Metropolitan Development Commission Plat Committee (August 14, 2024) Meeting Agenda

PLAT COMMITTEE **August 14, 2024**

Case Number: 2024-PLT-032

Request: Approval of a Subdivision Plat to be known as Mainscape Plaza Subdivision, subdividing 12.253 acres into two lots.

2024PLT031 ; Proposed Plat

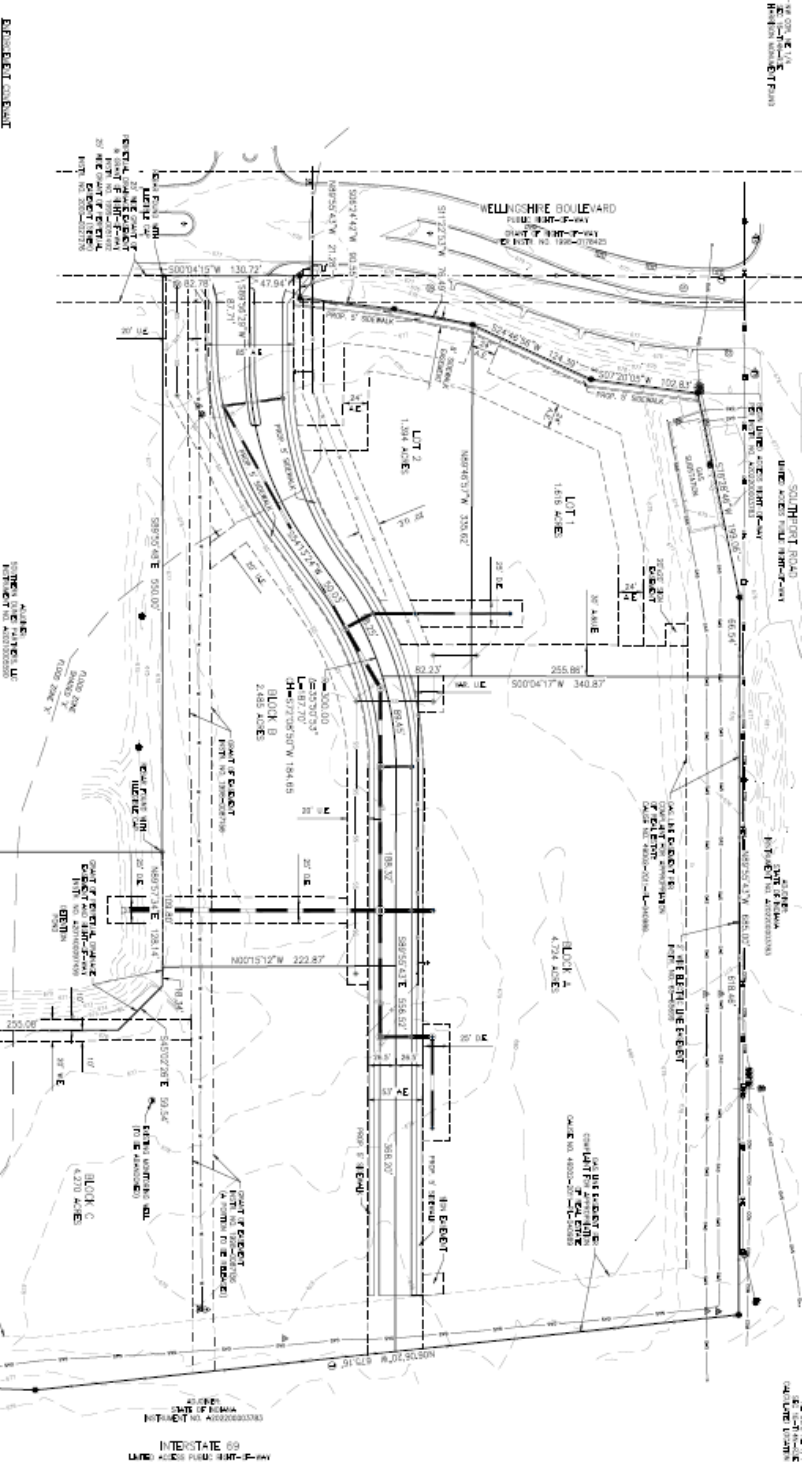
12. That the sidewalk waiver request be approved on the condition that pedestrian crosswalks and infrastructure are added across the southern and eastern legs of the intersection of Southport Road and Wellingshire Boulevard by the petitioner (subject to INDOT or DPW approval).

Both sides of Southport Road to the west of the subject site have sidewalks installed, as well as both sides of Wellingshire Boulevard (upon approval of the plat) and one side of Belmont Avenue to the northwest. No dramatic change in grade was noticed along the potential sidewalk area, and staff believes that increased pedestrian access to future businesses at the site would benefit both property owners and nearby residents. Sufficient evidence was not provided to justify the waiver, and staff recommends denial of the request. If the plat committee approves the waiver against staff’s recommendation, a contribution in lieu of sidewalk installation should be required as a condition of approval subject to Section 744-301.G.
